SERVICE BULLETIN

Subject: *Hayabusa-JK* Cargo Hook Keeper Lock

Document: 159-038-00

Revision: 0 Date: 05/13/16

Figure 1 – Failure scenario: Improperly loaded wire sling.

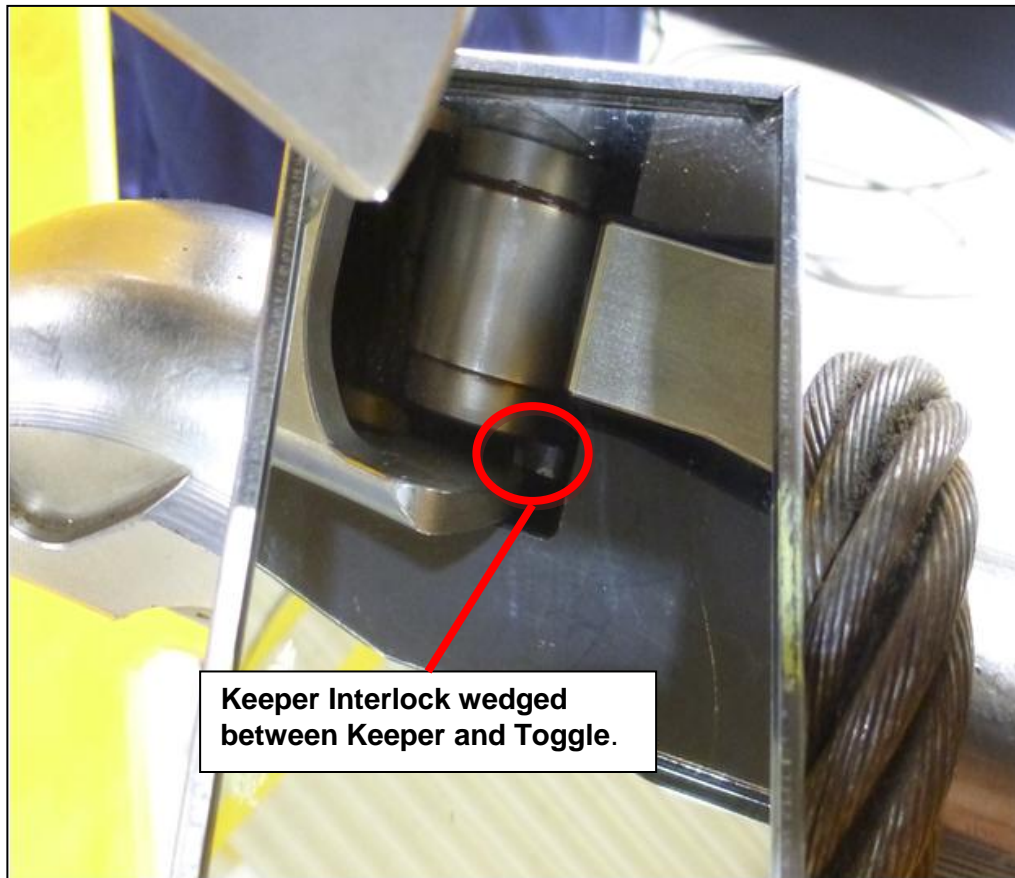
Description: There has been a report of a dropped load from *Hayabusa-JK* 10K Cargo Hook, part number 528-045-00. Investigation has concluded that the cause of the dropped load was an improperly loaded wire sling. The wire sling was supported against the keeper as shown in Figure 1, not actually resting on the load beam. During the lift, even though the keeper was partially open, the cargo hook reported a Keeper locked condition. The keeper lock indication resulted from deformation of the Keeper which allowed the Keeper Interlock to wedge into the space between the Toggle and Keeper. See Figure 2. When the Keeper Interlock is in this position, the Keeper is reported to be locked.

Solution: In order for the Keeper to properly lock as load is applied, it must be in the closed position. The Keeper will not lock if it is not closed as load is applied. No design change can prevent a dropped load due to mis-loading of the cargo hook as shown in figure 1. Ground crew must ensure that the cargo hook is properly loaded.

Figure 3– Keeper Interlock redesign

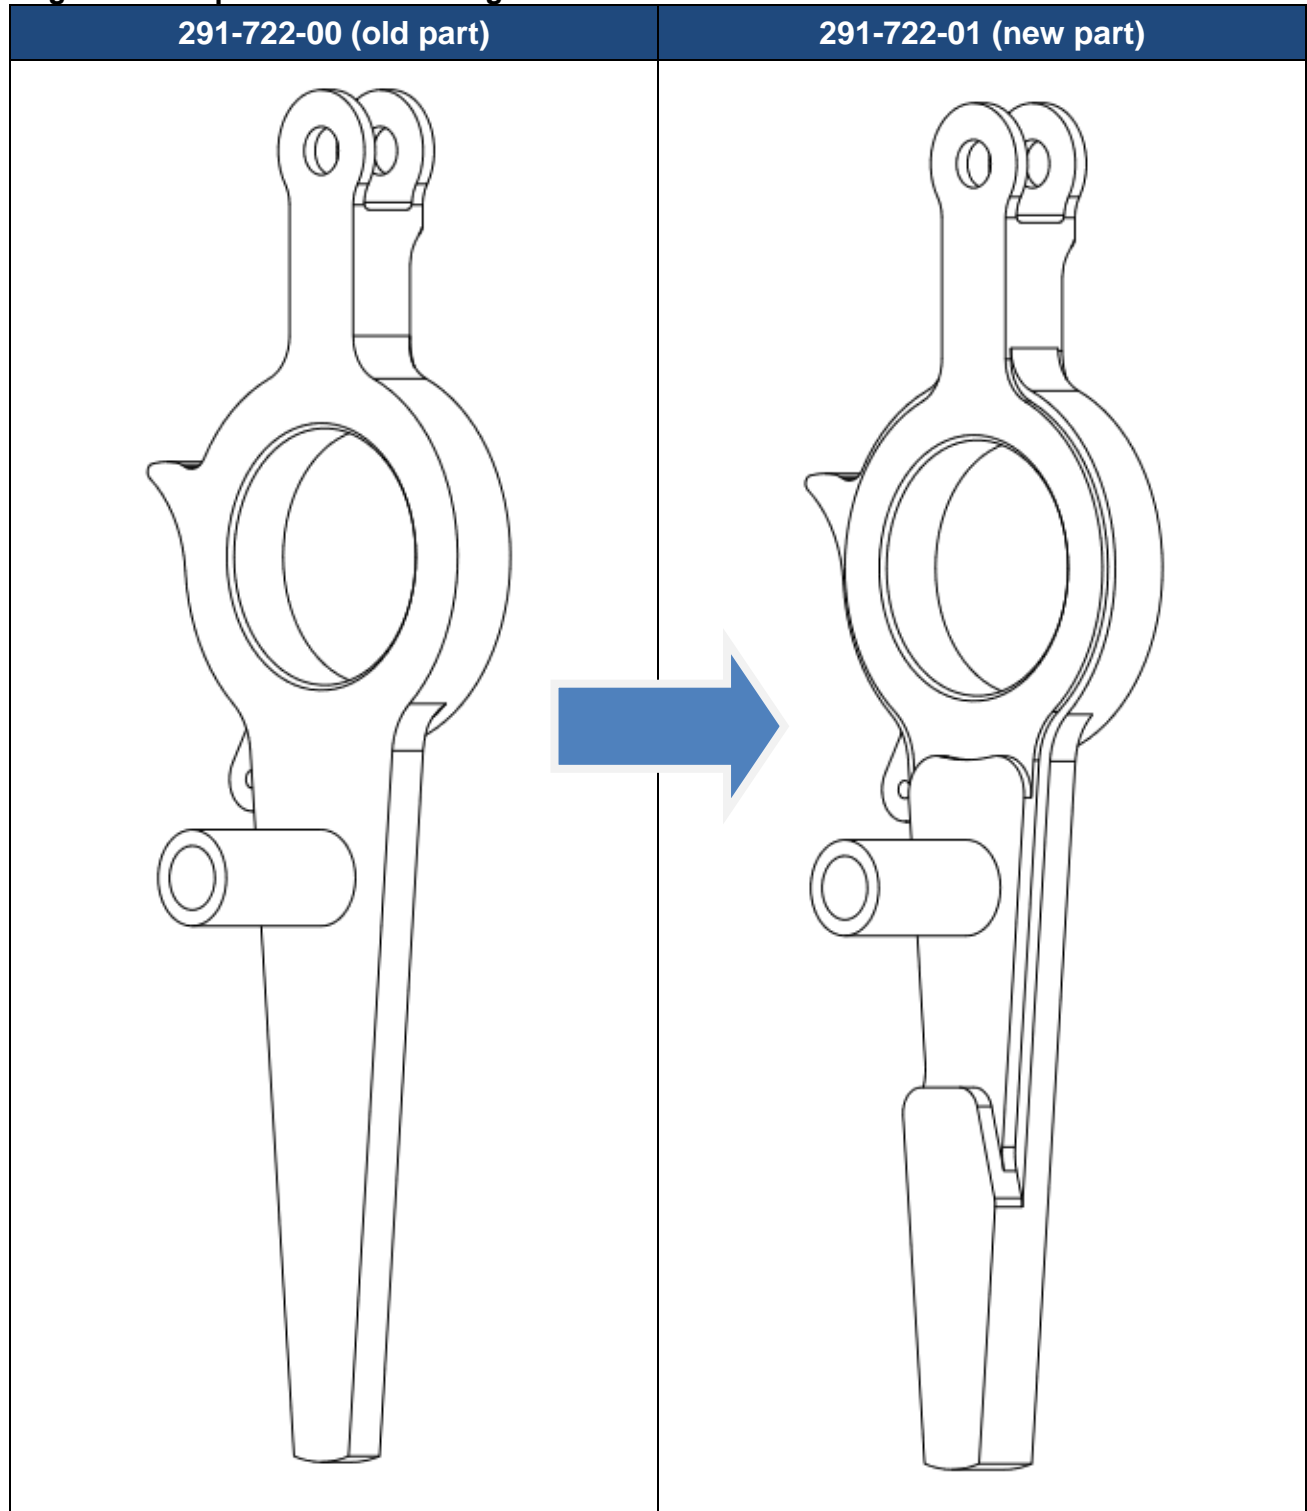
A minor modification however can be made to the cargo hook to avoid erroneous reporting of the keeper locked signal, giving the pilot opportunity to take action and avoid a dropped load. To accomplish this, the Keeper Interlock has been redesigned, see Figure 3. A modification to the cargo hook sideplates is required to accommodate the redesigned Keeper Interlock (291-722-01). The change will prevent wedging of the Keeper Interlock between the Keeper and Toggle and false reporting of the Keeper locked switch.

8. Reassemble cargo hook per owner's manual 120-210-00 and internal planning documentation. Install new Keeper Interlock 291-722-01. Apply fresh grease and PTFE lubrication.

Figure 4 – Sideplate Modification, P/N 291-711-00 (Hayabusa-JK 10K Cargo Hook)

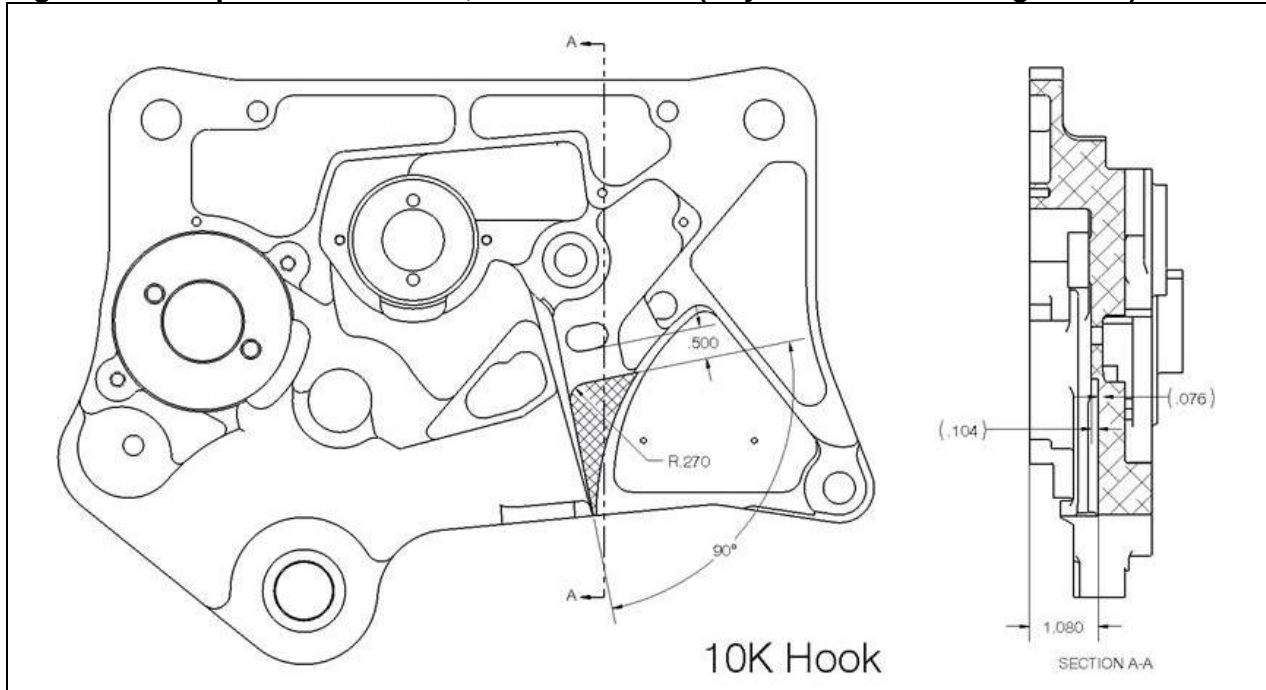
2. Perform CNC machining modification of sideplate per revision 8 (or later) for 291-711-00, and revision 5 (or later) for 291-756-00. See figures 4 and 5. Deburr and wash sideplate.

3. Inspect sideplate modification per figures 4 and 5 (QA).
4. Treat bare aluminum with alodine (519-033-00). Rinse and dry thoroughly. Apply 1 thin coat of 2-part MIL-P-23377 type I primer (519-028-00) using a foam or acid brush.

Figure 6 – Amendment marking of Serial Plate

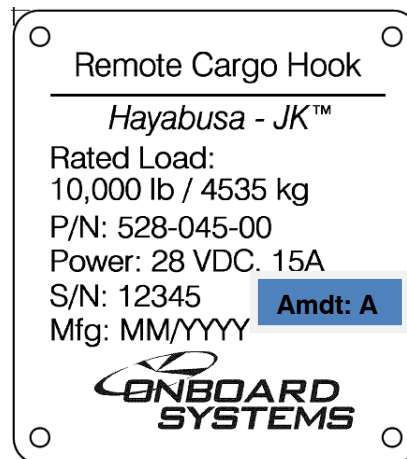
9. Mark the serial plate with "AMDT: A" using a decal, or alternatively metal stamp 'AMDT A' with 1/8" character steel stamps.
10. Perform ATP in accordance with 180-229-00 or 180-230-00, as applicable. Place copy of ATP with cargo hook.

Configuration Management: Compliance with this Service Bulletin will be denoted as Amendment A (AMDT: A). The part number and the serial number of the Cargo Hook do not change. See serial plate example below.
